Slow Seat Belt Retraction. 2006 to 2011 Miatas

Service Information

Category S	Repair Guidance	Ref. No. R086/10A	Page 1 of 3
Coverage <input type="checkbox"/> Distributor only <input checked="" type="checkbox"/> Please inform your dealers		Date Issued October 29, 2010	
Please convey this information to your <input type="checkbox"/> Director <input checked="" type="checkbox"/> General Manager <input checked="" type="checkbox"/> Warranty Dept. <input checked="" type="checkbox"/> Parts Dept. <input checked="" type="checkbox"/> Training Dept. <input checked="" type="checkbox"/> Field Rep.		Date Revised December 8, 2011	
Applicable Model MX-5/Miata (NC)		Applicable Countries or Specifications Worldwide

Subject: Poor Seat Belt Retraction

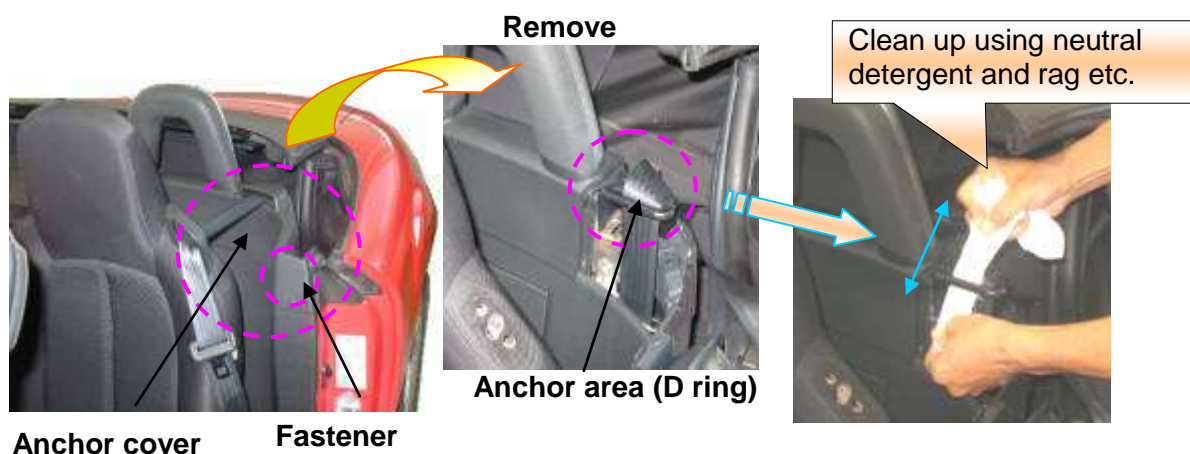
1. Confirm the retraction performance:

Fully pull out the seat belt and keep it in this position by hand. Release it and confirm the duration between releasing and completely pulling back.

Avoid any interruption and resistances such like seat belt rubbing to the front seat while retraction, by assisting and guiding the belt with another hand during the retraction.

If it takes about 2 seconds or less, the retraction performance is within the specification.

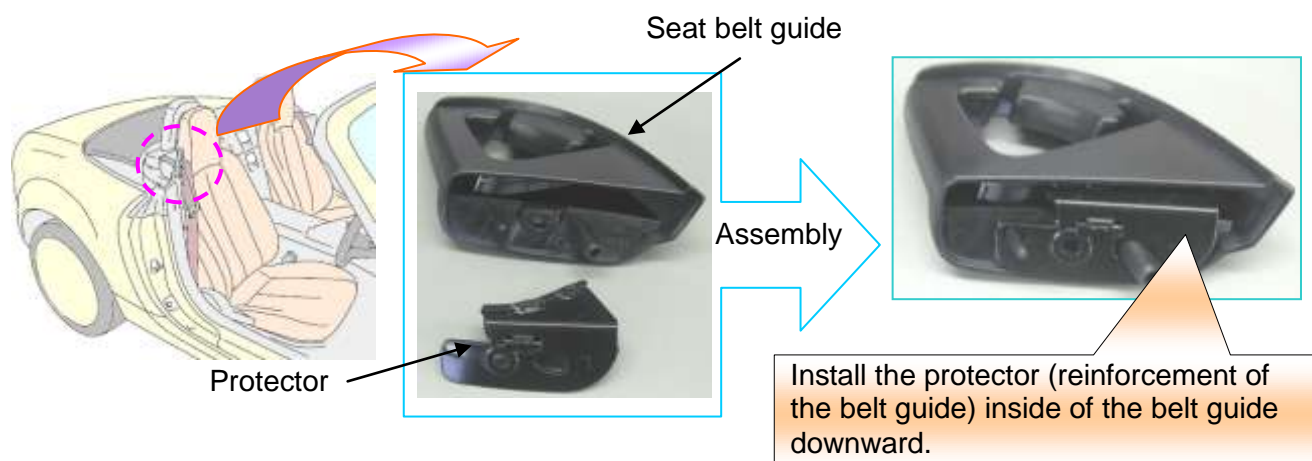
2. Remove dirt, dust, smudges from the seat belt, the belt guide and the anchor area according to Owner's Manual:

Clean the webbing with a mild soap solution recommended for upholstery or carpets. Follow the instructions. Don't bleach or dye the webbing, this may weaken it. After cleaning the belts, thoroughly dry the belt webbing and make sure there is no remaining moisture before retracting them.

***Cleaning of anchor area:** Remove the fastener and the anchor cover to remove smudges on the seat belt anchor area (D ring).

Confirm the retraction performance after cleaning.

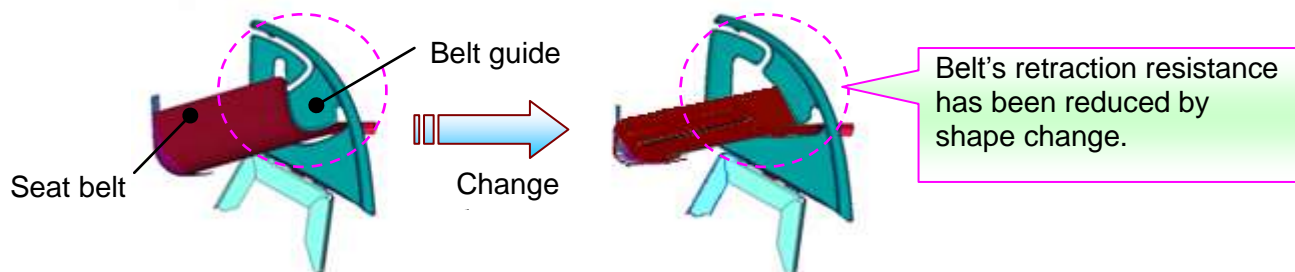
3. Replace the seat belt guide & the protector with the modified ones. (Both Sides)

(1) Remove the seat belt guide (combined with the protector).

Loosen the attachment screw and remove the seat belt guide & protector.

(2) Assembly new seat belt guide & new protector, then install it using original screw.

Note: *The shape of the belt guide (Service parts) has been changed as illustration.

(3) Confirm the performance of seat belt retraction and if it's not improved, clean up the seat belt & anchor area again.
